Nancy Tran Land Use Board Secretary Borough of Highlands Land Use Board 151 Navesink Avenue Highlands, New Jersey 07732

Re: Completeness Review No. 1 Applicants: Edward and Lori Pahler Block 54, Lot 13 35 Miller Street Borough of Highlands, Monmouth County, New Jersey Our File No.: HLPB25-09

The Applicant seeks to construct a 2 $\frac{1}{2}$ story single-family dwelling on an existing vacant lot on which a multifamily dwelling recently stood. The proposed residential building will consist of three (3) bedrooms with site improvements and 3 parking spaces (garage under (2) and driveway).

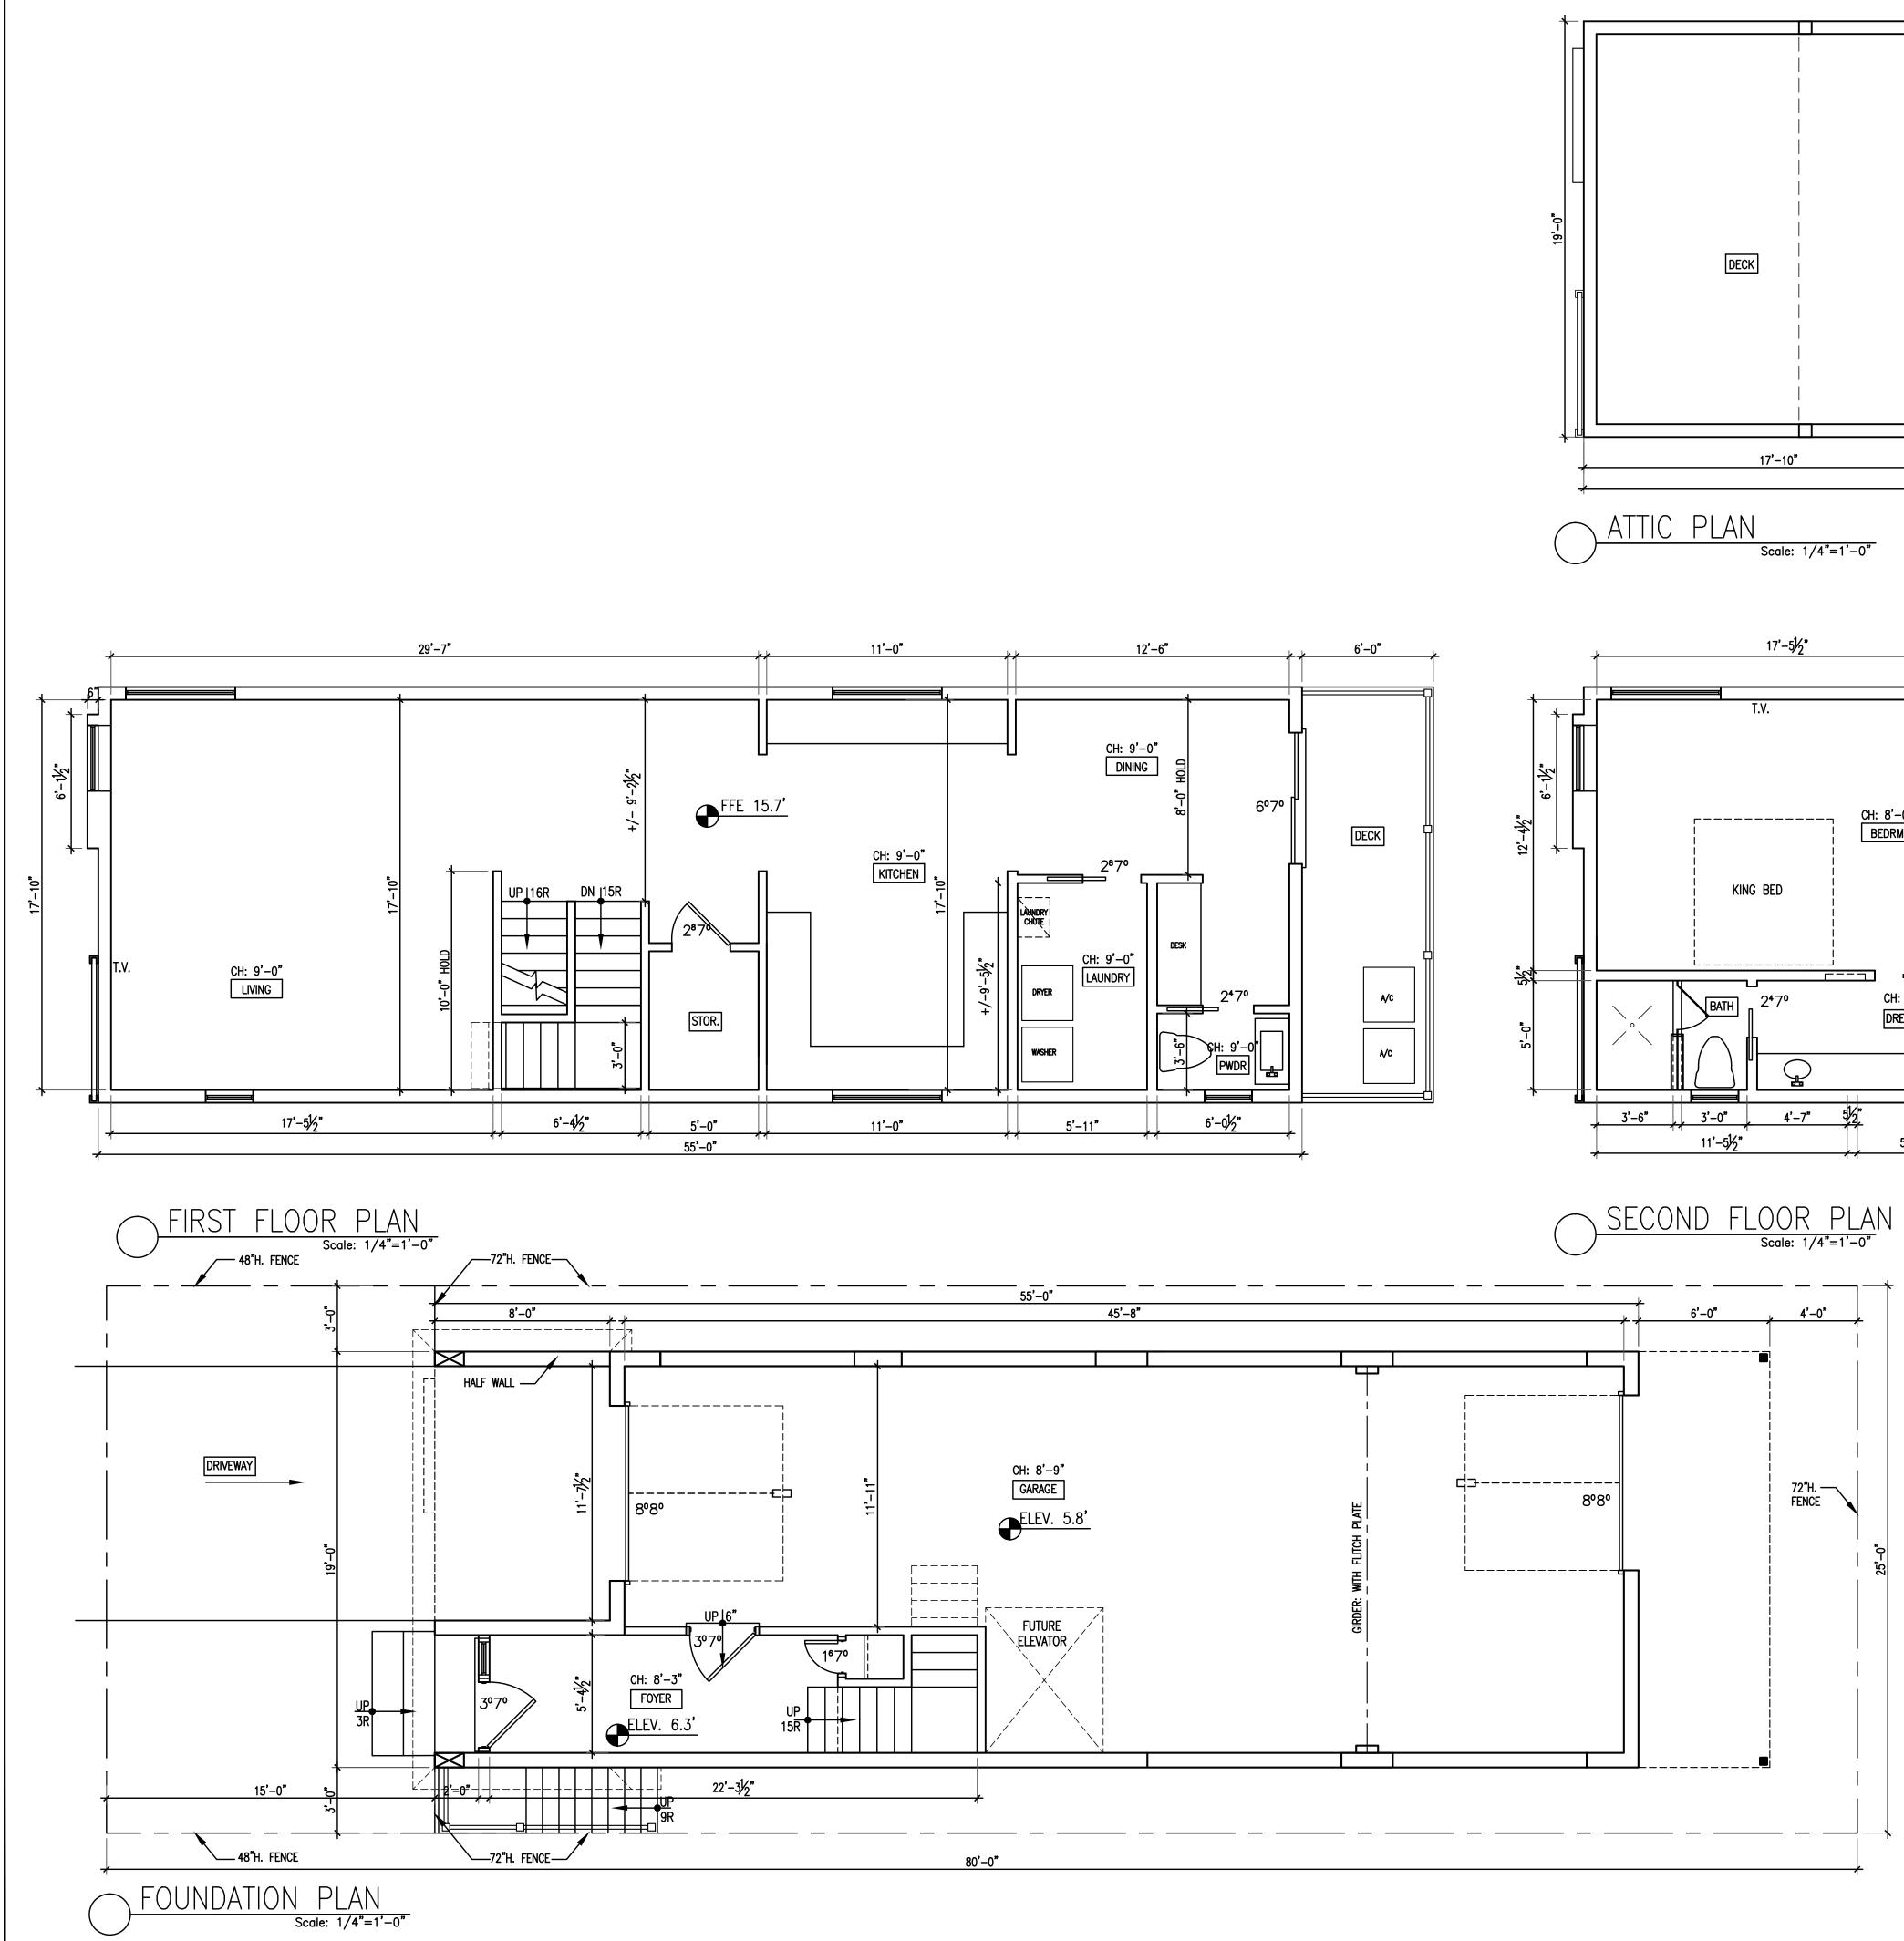
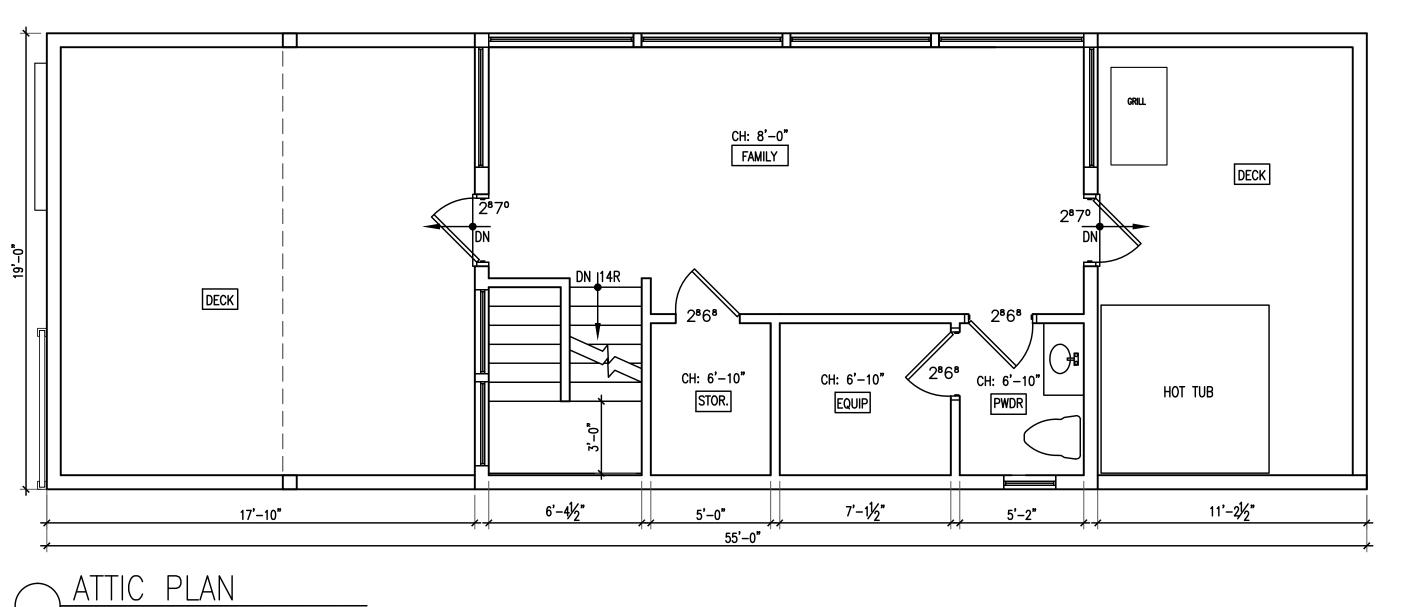
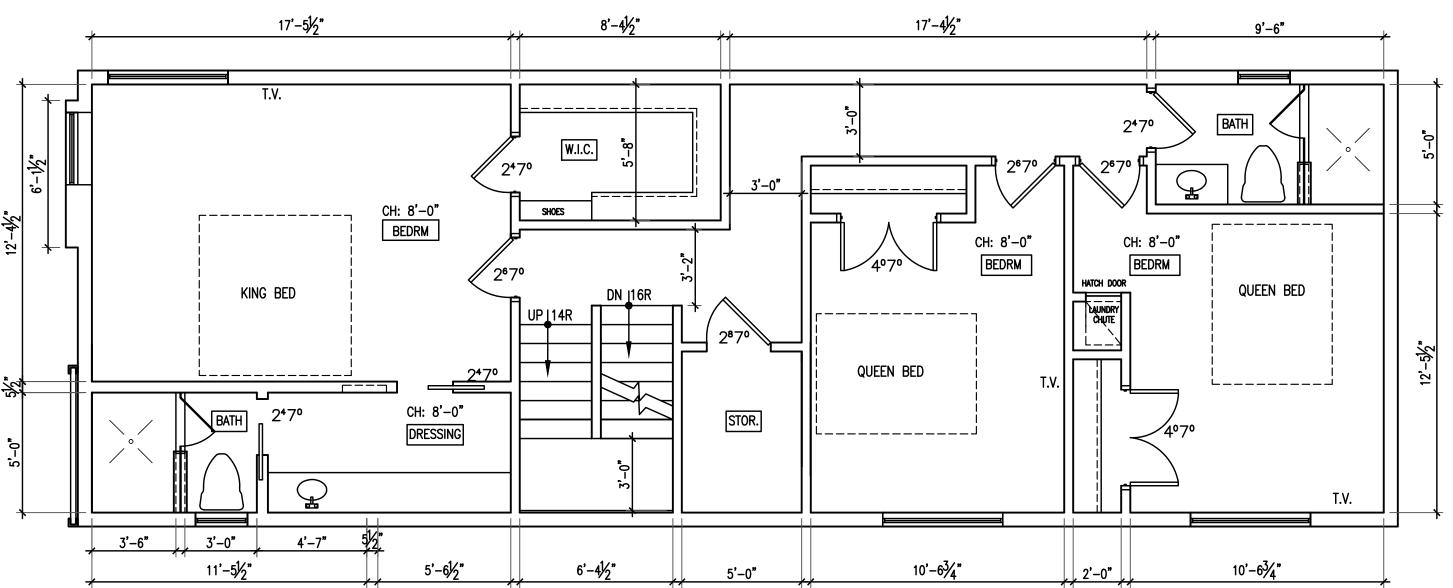
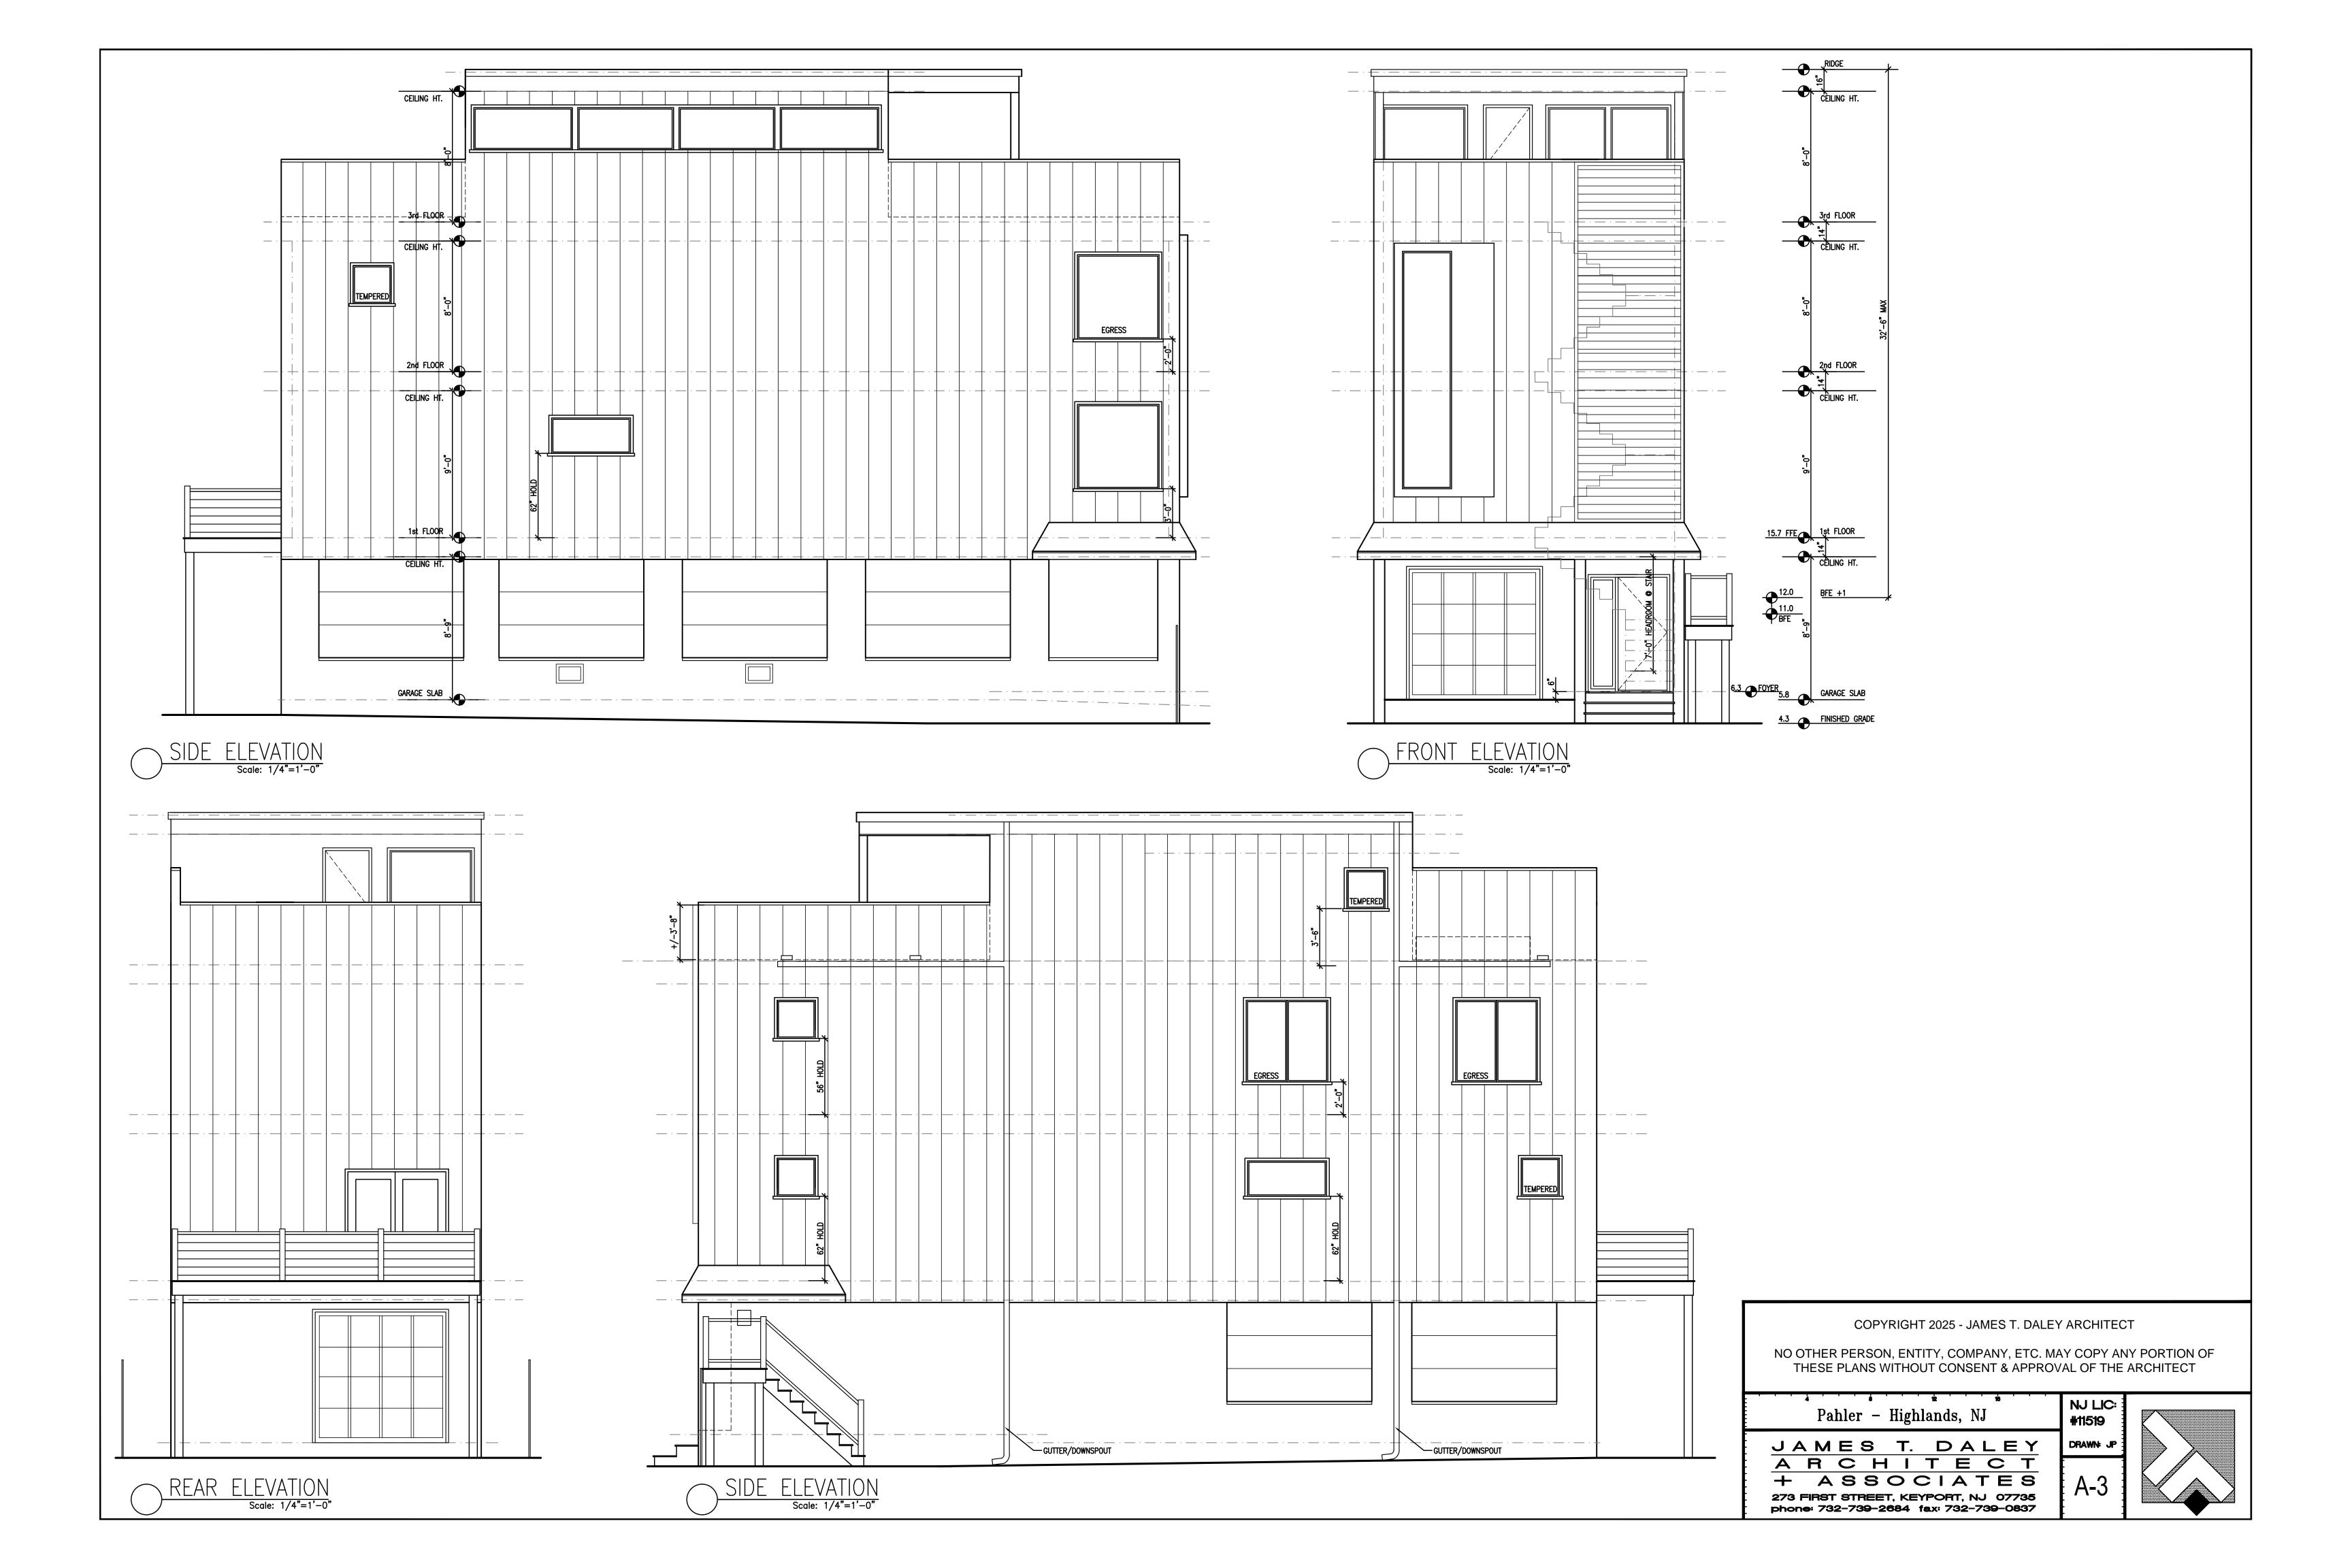
- 1. Please rename the plan to Site Plan.
- 2. Please provide signed and sealed Architectural plans.
- 3. The Applicant has submitted an application for a 2 ½ story dwelling, however it appears that the proposed dwelling is more than 2 ½ stories. The attic has an 8-foot ceiling height with family space and a bathroom. The dwelling appears to be three stories. Please provide testimony.
- 4. Please provide a Certification statement on the engineering plan. Refer to Checklist Item #22.
- 5. Please provide the location of all structures within seventy-five (75) feet of the property.
- 6. Please update the minimum lot depth as compliant.

- 13. A proposed 4 ft x 3 ft utility platform with 6 ft high fencing and steps extends from the dwelling to the property line. The platform appears to be needed for access to the E-meter and HVAC units.

- a. According to §21-123.2 mechanical, plumbing and electrical systems should be above Local Design Flood Elevation (LDFL). The utilities and E-Meter appear to be placed above the LDFL elevation of 12 ft high (Local Design Flood Elevation) according to the architectural elevations.

- b. The proposed fence enclosed platform blocks direct access to the side yard leading to the rear yard without trespassing on the adjoining property.
